Change Order

PROJECT (Name and address):	CHANGE ORDER NUMBER: 005	OWNER: <input checked="" type="checkbox"/>
Cecilia Valley Elem School Elizabethtown, KY	DATE: June 26, 2017	ARCHITECT: <input checked="" type="checkbox"/>
TO CONTRACTOR (Name and address):	ARCHITECT'S PROJECT NUMBER: 1429 / BG 13-017	CONTRACTOR: <input checked="" type="checkbox"/>
Isaac Tatum Construction, Inc. PO Box 665 85 Sulfur Springs Road Lebanon, KY 40033	CONTRACT DATE: May 27, 2016	FIELD: <input type="checkbox"/>
	CONTRACT FOR: General Construction	File 1429 B/CO (Ecocy): <input checked="" type="checkbox"/>

FLOOR FINISH REVISION @ ADMIN AREA, CASEWORK REVISION FRC 108

SHEET NO.	PR005-A
DATE	11/17/16
DRAWN	CTM

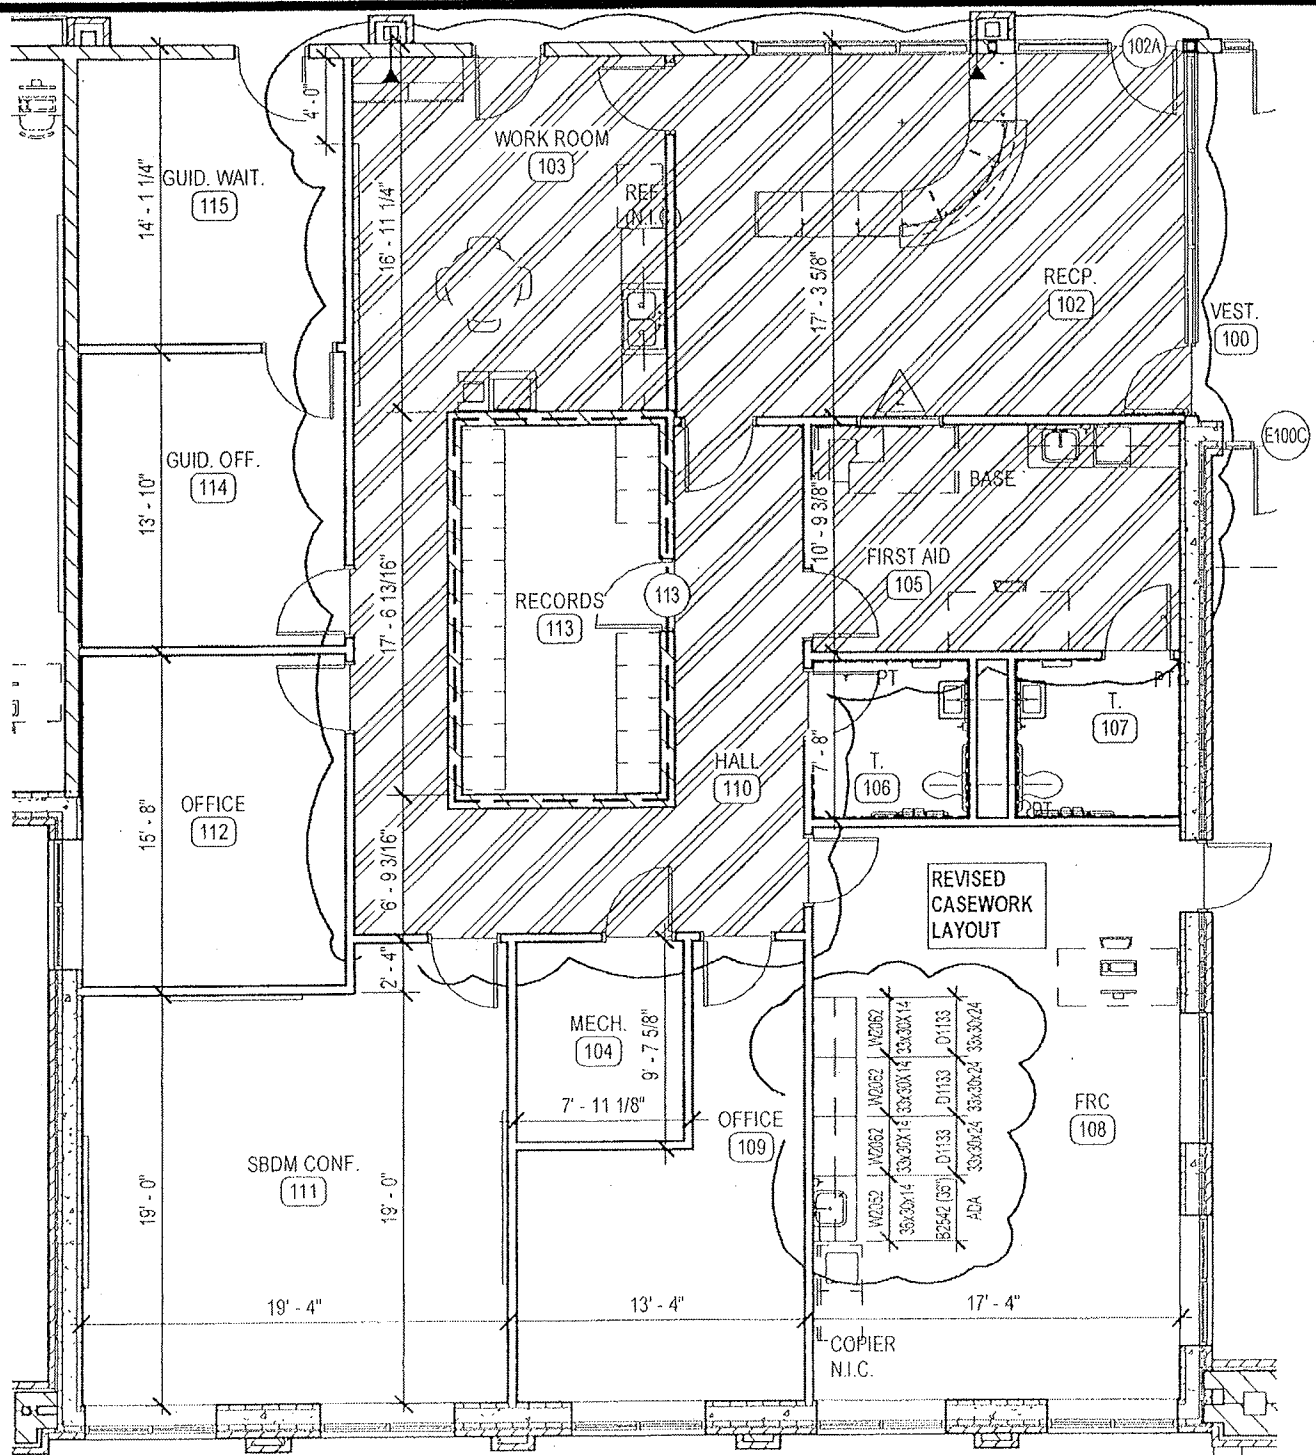
Omit linoleum flooring in Reception – 102, Work Room - 103 and First Aid 105. Omit carpet in FRC – 108 and Hall – 110. Within all rooms noted above, flooring to be polished, stained and sealed concrete.

Also, within FRC – 108 omit 3 wardrobe units (F2586). Provide base cabinets, wall cases and countertop. Refer to Drawing PR005-A

Replace 3 tall Cabinets with Wall/ base /top	\$0.00
Deduct for Linoleum(RMS 102,103,105)	-\$4,687.00
Deduct for Carpet(RMS 108,110)	-\$4,600.00
<u>Add for Polish concrete Unit Price</u>	
1545 Sq FT. @ \$3.85	\$5,948.25
